Design and Access Statement Plot B - Addendum

01997-WEA-OXFORD NORTH PLOT B-DAS-ADDENDUM-P02

Fore Court Facade Angle

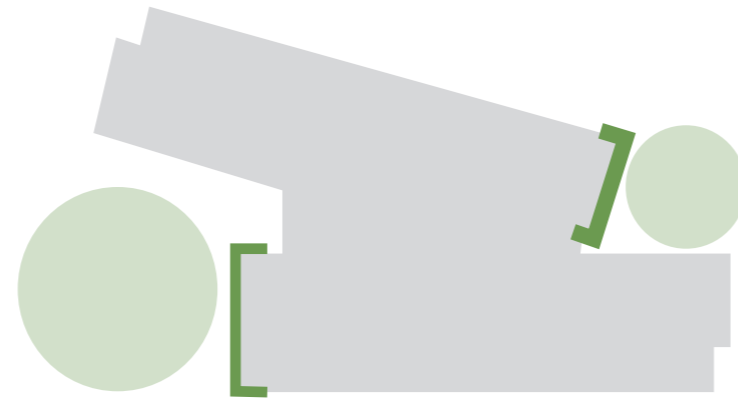
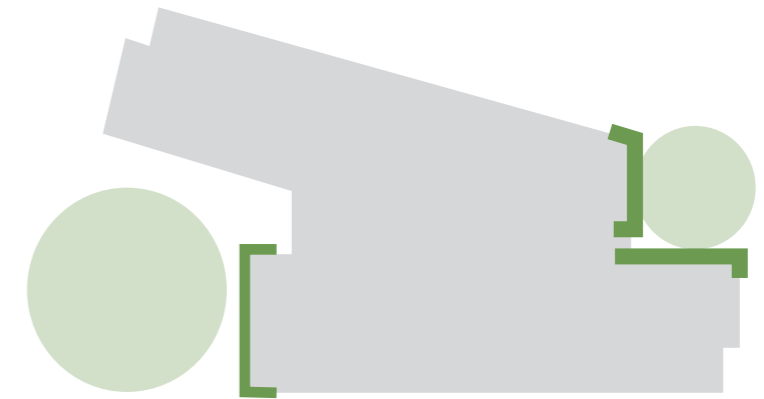
The key change to the scheme has been the reworking to the eastern end of the north wing to the building. Following buildability reviews with the preferred main contractor, the acute junction of the entrance elevation was identified as an area of significant complexity and difficult construction detailing. Therefore the design team reviewed an alternative orientation of this facade that was also considered could improve the composition of the forecourt space.

By amending the angle of the return elevation it was felt this entrance facade better framed the external forecourt space. As well as removing the awkward angle, it was felt the visibility of the entrance screen was improved. The width of the glazing screen was increased to provide a more open and transparent frontage. It was considered that this would enhance the relationship between the internal and external spaces.

The recess glazing between the north and south wings has been retained. This was valued as a key element to separate the volume of the wings of the building in line with the original concept.

Concept diagram with gable end volumes designed to respond with adjacent landscape spaces, enhanced by 'squaring' up the facade to the forecourt

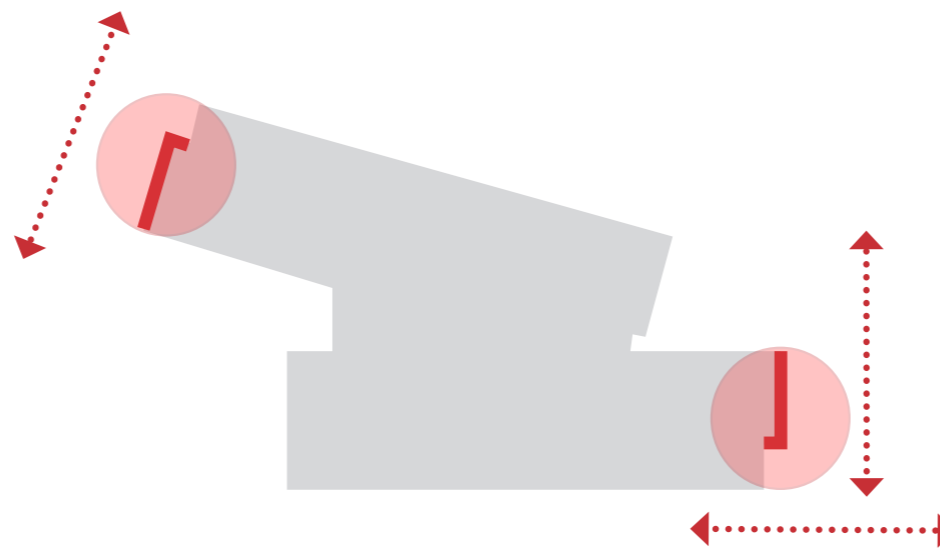
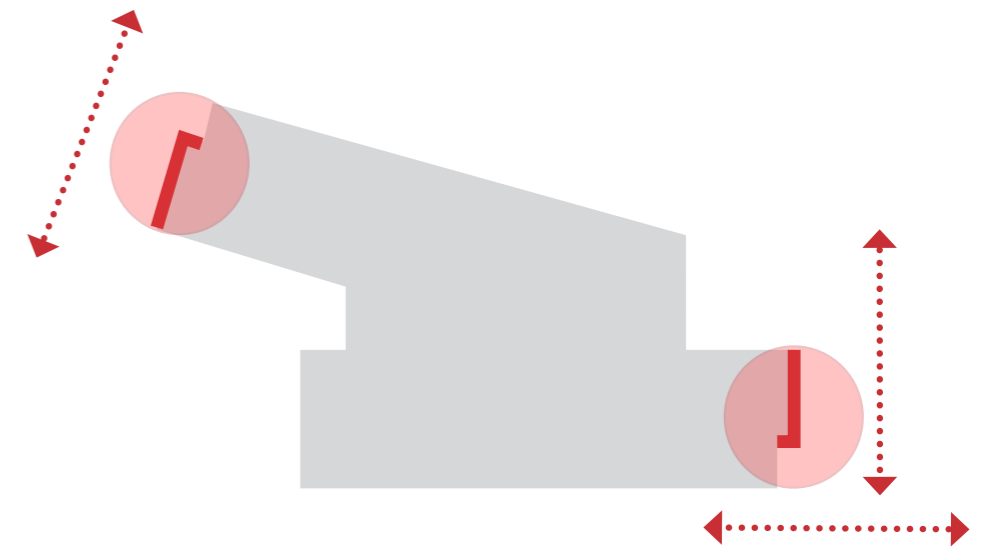
The concept of articulation of the western and eastern corners responding to the key views of the building has looked to be strengthened.
